Product/Process Change Notice (PCN)

PCN_IndTPC_20141126:

Product Affected: WE-TPC 2813 series

Part no. affected: 744029xxx

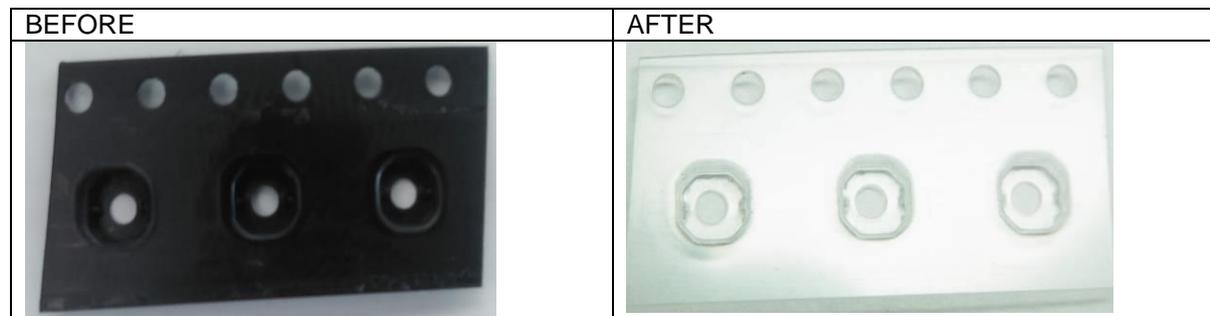
Due to a better control in the Marking Positioning Process on the production line, the carrier tape will be changed from black colour to transparent colour.

The new transparent carrier tape will have the same dimensions as the current black tape; only the colour of the carrier tape will be changed, as seen in the picture below.
